**Identification cards — Contactless
integrated circuit cards — Proximity
cards —**

**Part 3:
Initialization and anticollision**

**AMENDMENT 1: Electromagnetic
disturbance handling and single-size unique
identifier**

AMENDMENT 1: Electromagnetic disturbance handling and single-size unique identifier

Page 4, Clause 4

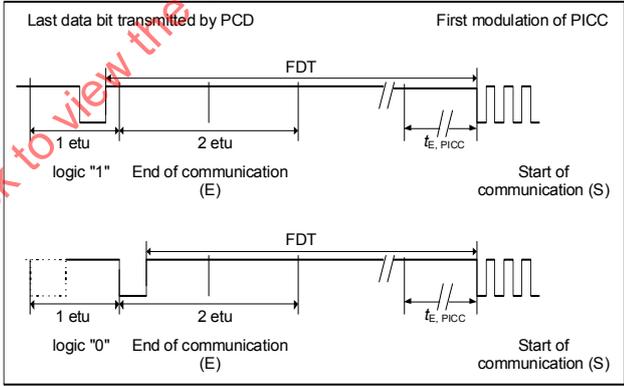
Insert the following new symbols between SOF and TR0:

$t_{E,PICC}$ Low EMD time, PICC

$t_{E,PCD}$ Low EMD time, PCD

Figure 17 — Timing before the PICC SOF

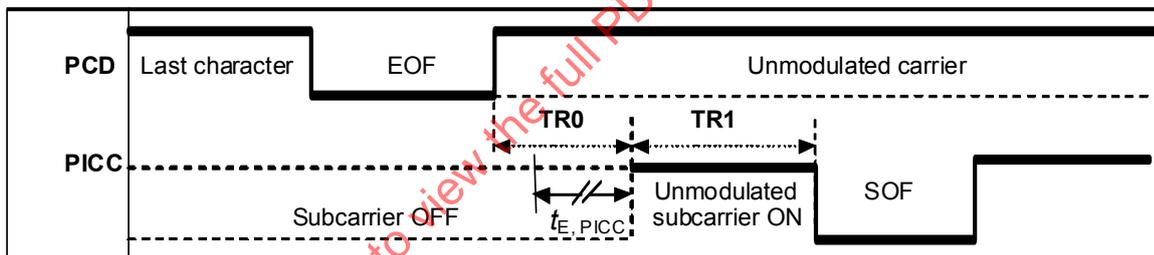
Replace Figure 17 with the following:

NOTE $t_{E,PICC}$ is specified in Clause 8.

Figure 33 — Low EMD time

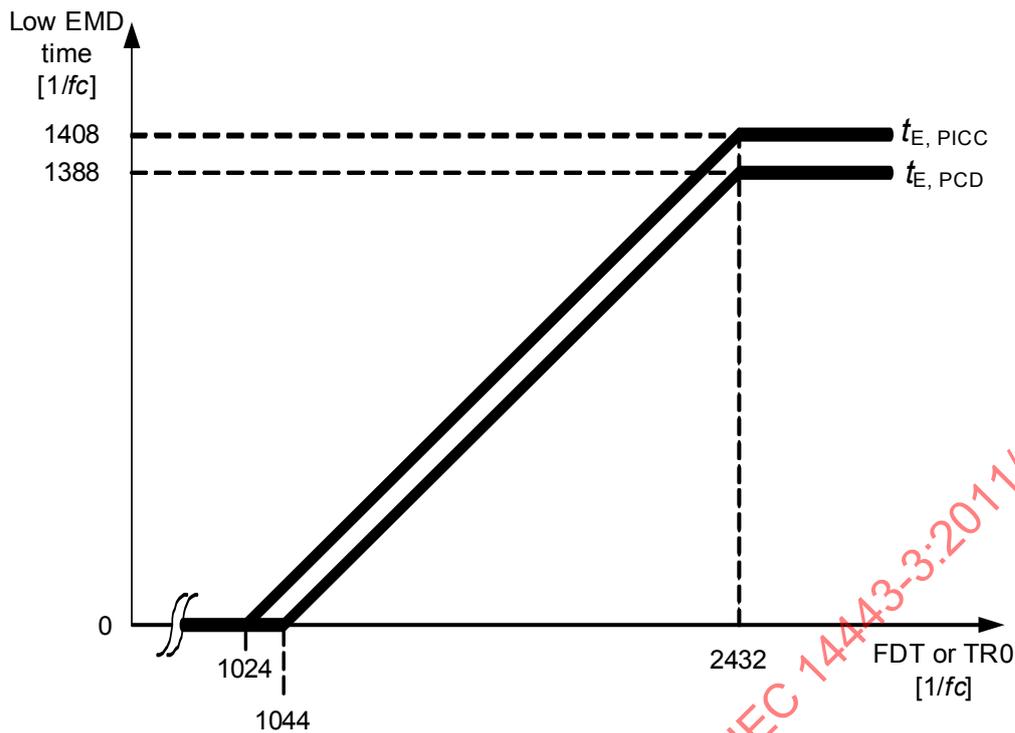
The low EMD time $t_{E,PICC}$ is the time period before the start of PICC data transmission, when the PICC shall not produce an EMD level higher than the EMD limit as defined in ISO/IEC 14443-2/Amd.1.

This low EMD time $t_{E,PICC}$ has a value of $F - 1024/fc$ with a maximum value of $1408/fc$ where F equals FDT for Type A and TR0 for Type B. The value is $0/fc$ for $TR0 \leq 1024/fc$.

The low EMD time $t_{E,PCD}$ is the time period to allow the PCD to recover from electromagnetic disturbances.

The PCD shall be ready to process a PICC frame no later than $t_{E,PCD}$ after the last time the EMD level was above the EMD limit as defined in ISO/IEC 14443-2/Amd.1.

This low EMD time $t_{E,PCD}$ has a value of $F - 1044/fc$ with a maximum value of $1388/fc$ where F equals FDT for Type A and TR0 for Type B. The value is $0/fc$ for $TR0 \leq 1044/fc$.

The low EMD time for PCD and PICC are illustrated in Figure 33.
